California Wind Energy Association

RE: Docket No. 15-RETI-02 -- Comments of the California Wind Energy Association following the April 18, 2016, Renewable Energy Transmission Initiative 2.0 Plenary Group Meeting

PC-21 Heavily Utilized Paths

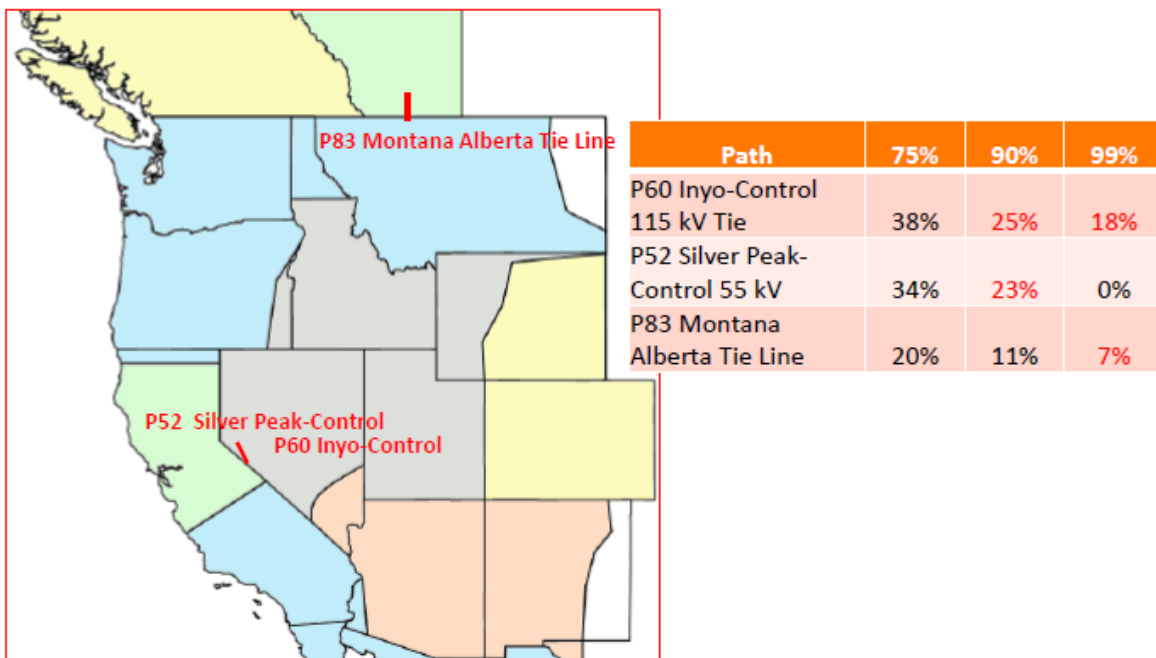
A map and a table accompany the above question on Mr. Turner's slide 9 that are apparently drawn from a WECC reliability study presented at a January RETI 2.0 workshop.¹ The slide shows considerable transmission congestion resulting from a WECC case study called "PC-22: High Renewables." However, another case study – "PC-21: Coal Retirement" -- was conducted by WECC along with PC-22 but was not presented at the January RETI 2.0 workshop.² Very interestingly, PC-21 shows that little or no congestion occurs with coal-plant retirements and significant renewable energy additions across the WECC footprint. (See PC-21 slide reproduced below.) Specifically, the following can be gleaned from PC-21:³

- The retirement of over 6,000 MW of coal units that are already scheduled to occur by 2024 will enable approximately 3,500 MW of wind energy and 1,800 MW of solar to be accessed through dynamic transfer (DT) arrangements with the CAISO (or via an expanded CAISO) without any transmission upgrades.⁴
- The retirement of 16,000 MW of coal capacity (about half that now operating) would enable 9,600 MW of wind and 4,800 MW of solar to be dynamically scheduled with very modest transmission upgrades.⁵

⁴ This result can be inferred by scaling down the assumed 16,626 MW of coal retirements in PC-21 by the amount of announced coal retirements (which total 6,157 MW by 2024). Because congestion was found to be very limited under PC-21 assumptions, it is reasonable to assume that scaling down the assumptions by 63% would produce no congestion. This transmission capacity can be utilized for the purpose dynamic scheduling resources into the CAISO.

⁵ Slide 11 from the October 2015 WECC presentation shows that just three transmission paths become constrained under PC-21; CalWEA believes these paths can be relatively easily and cheaply upgraded.

By contrast, PC-22 assumes the retirement of 6,000 MW of coal and a significant amount of gas-plant reductions, which would enable almost 17,000 MW of wind and 15,000 MW of solar but would require a significant number of transmission upgrades (as reflected in the map on Mr. Turner’s slide 9). Note that this case produces less CO₂ reduction than PC-21.
